STAFF REPORT

May 27, 2020

AGENDA ITEM: VII-A (File No. SPAR-20002)

Consideration of a Site Plan and Architectural Review application for the development of a 6,262 square foot automobile care and tire facility, including parking and landscape areas. The 1.0 acre project site is located at 4245 Table Rock Road within the Tourist and Office Professional (C-4) zoning district and is identified on the Jackson County Assessor's map as 37S 2W 01C Tax Lot 700. **Applicant:** Zaremba Group; **Agent:** Amy Gunter; Rogue Planning & Development Services, LLC.

Attachment "A-1"

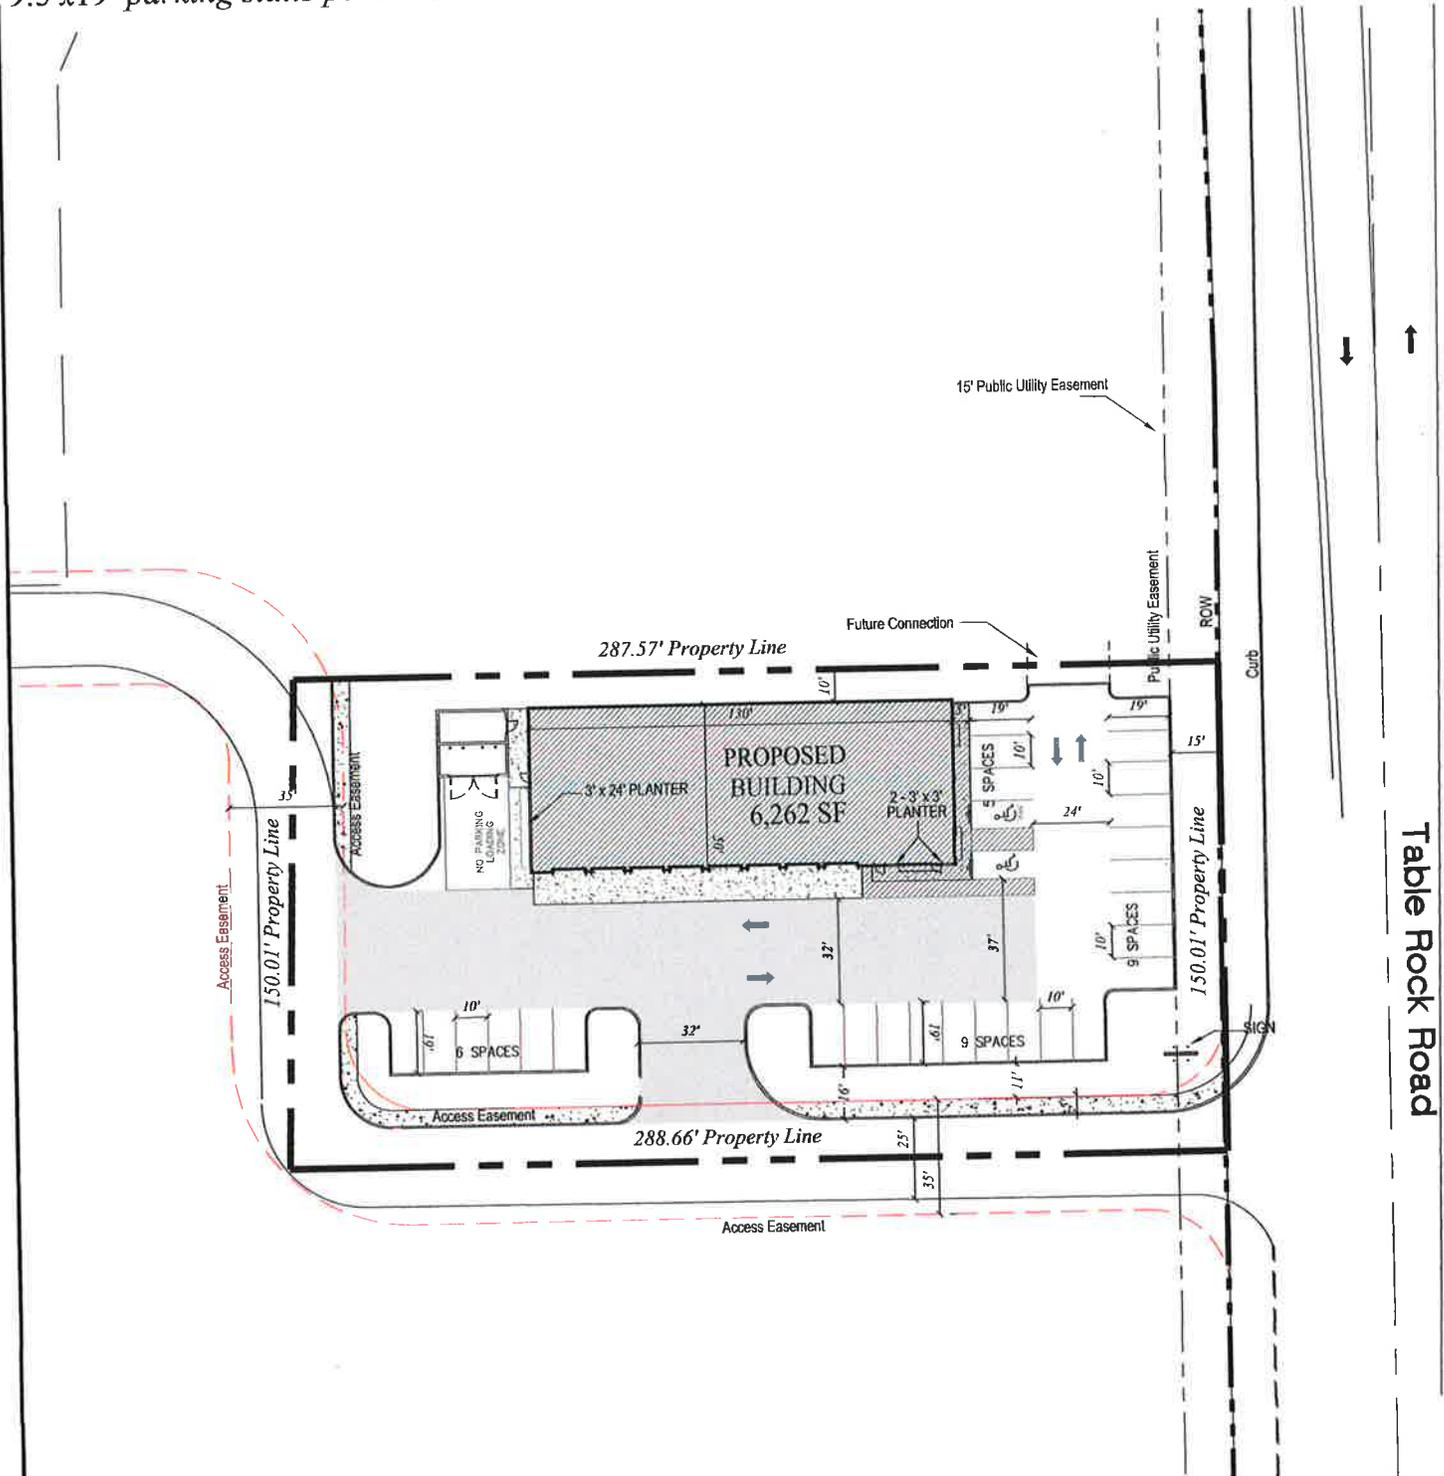
3. **Bicycle Parking.** Per Table 17.64.04, CPMC 17.64.040, bicycle parking must be provided for automobile oriented commercial uses and the proposed use requires a minimum of 2 bicycle parking spaces. Bicycle parking is not provided on the plans.

Comment: Despite the auto-centric nature of the use, traffic to the site is generated by customers and employees. Staff recommends Condition of Approval No. 1(c), requiring the applicant to provide a revised site plan demonstrating compliance with the minimum bicycle parking standards in Section 17.64.040(I) before building permit issuance.

- c. Provide a revised site plan that depicts the location of a minimum of two (2) bicycle parking spaces demonstrating conformance with Section 17.67.040(I).

TENTATIVE PLAT
TABLE ROCK CROSSING SUBDIVISION

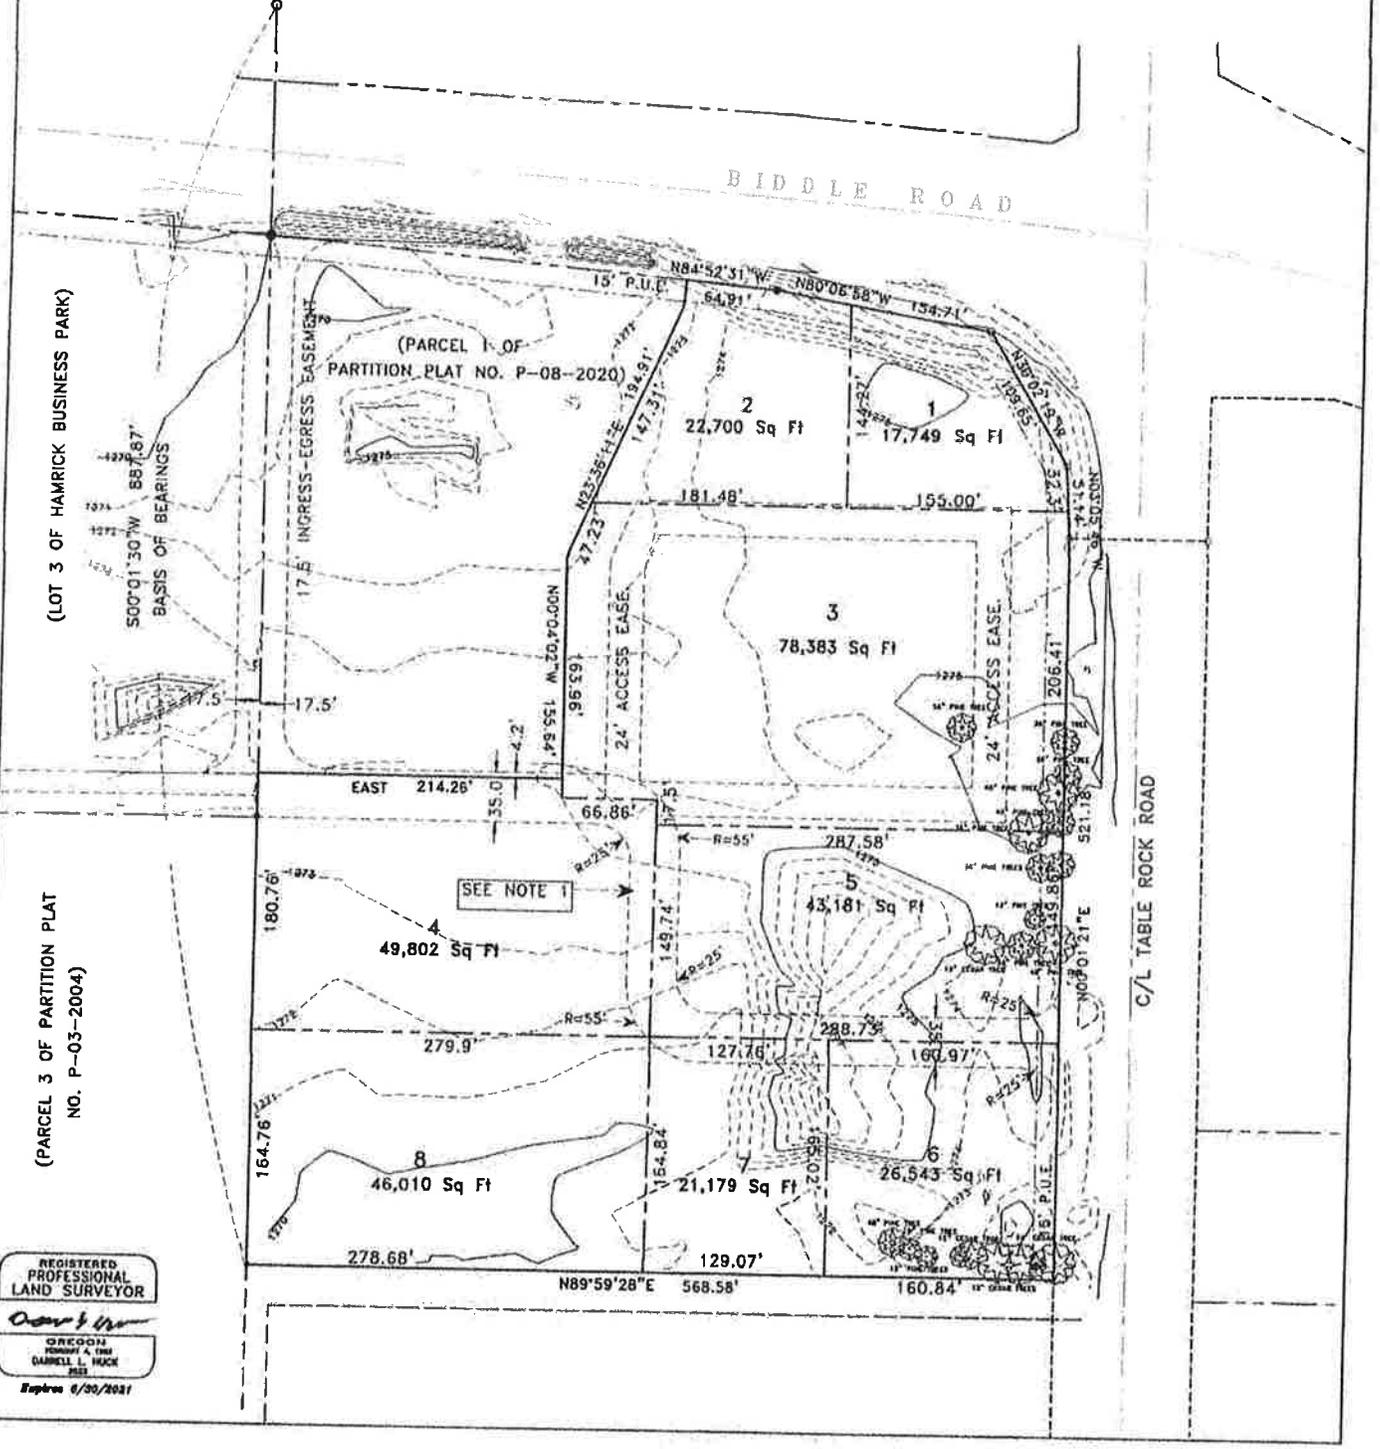
1. **Final Plat/Subdivision Improvements.** The subject property is identified as Lot 5 of a Tentative Plan (SUB-20001) for a commercial subdivision (Attachment “A-4”). The Tentative Plan has been approved by the City, but the subdivision improvements have not been completed and the Final Plat for the subdivision has not been recorded.

Comment: It will be necessary to complete the public and private improvements in order to complete the Final Plat process for the proposed subdivision. Staff recommends Condition of Approval No.1(b) requiring a recorded copy of the final plat and complete subdivision improvements prior to building permit issuance.

- b. Demonstrate that all Final Plat requirements for the 8-lot commercial subdivision (SUB-20001) are completed and provide a recorded copy of the Final Plat to the Community Development Department.
